# Forebay Park Public Outreach Meeting Summary

An onsite public meeting was held at Forebay Park in Pollock Pines, CA on Wednesday, May 18, 2022 from 6:00pm to 7:30pm. The open house format consisted of a presentation by HELIX. The presentation included:

**Figure 2 – Forebay Park Improvement Zones**

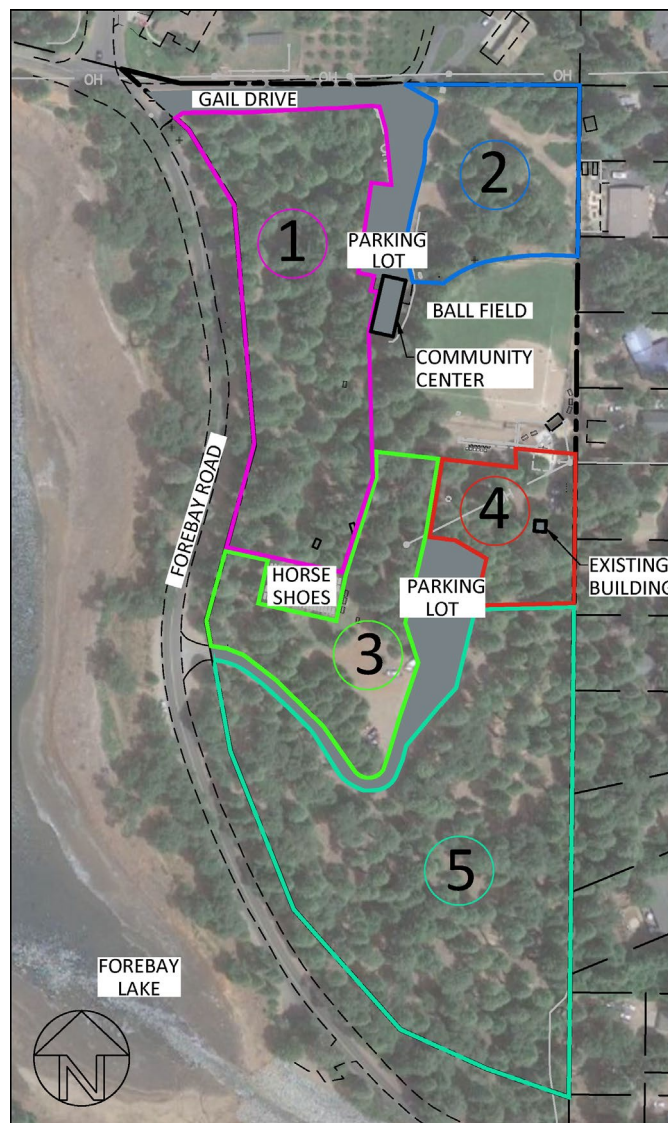
Area 1: (Proposed walking paths & disc golf)

- Attendees expressed concern that this area was too small for a disc golf course and wondered if that was a worthwhile use for only a few baskets.
- There were concerns about errant discs running into the traffic along Forebay Road or other park users.
- Attendees pointed out how strongly disc golf was supported on the survey although that contingent was not present at the in-person meeting.
- It was suggested that a gathering area, such as a rentable group picnic area, near the community center would be valuable. This would enhance the park's function for group gatherings.

Area 2: (Proposed a dog park)

- Attendees wanted separate areas for small and large dogs.
- Attendees wanted to retain the trees within the dog park.
- Adjacent property owners voiced concerns about the impact of a dog park so close to their homes and suggested that a larger buffer, such as a 50' buffer, would help to minimize the impacts.
- It was recommended the dog park be placed closer to the parking lot.

Area 3: (Proposed restroom, horseshoes, extension of walking and disc golf)

- Restrooms overall were highly desired and people said they get high use from others including delivery drivers.
- Restroom use generated curiosity as to whether they would be open 24/7 and if they would be locked.
- The president of the horseshoe club requested a shed (10'x10') near the horseshoe area.
- The exposed dirt area is currently used as necessary overflow parking and cannot be used for disc golf or a walking path.

Area 4: (proposed playground, exercise equipment, maintenance road)

- Some people thought it would be nice to have the exercise equipment spread out along the walking path while some considered it possibly unsafe for people to be using equipment in remote locations due to health and privacy concerns.
- Conesus was to move the exercise equipment down to the north end of area 5.
- General support for the playground in this location.

Area 5: (Proposed bike pump track or disc golf & walking paths)

- Many residents whose property abuts this area had concerns about cleanliness, trespassing, privacy, and fire safety. They have experienced people driving through their property as well as trespassers within their property line.
- Attendees see a lot of wildlife in this area and don't want to a lot of trees torn down.
- Some residents voiced concerns over erosion from an unpaved trail.
- There was not strong support for the bike pump track nor the disc golf.
- Attendees wanted to see a paved multi-use trail that can be used by walkers, strollers, wheelchairs, bicycles, and scooters.
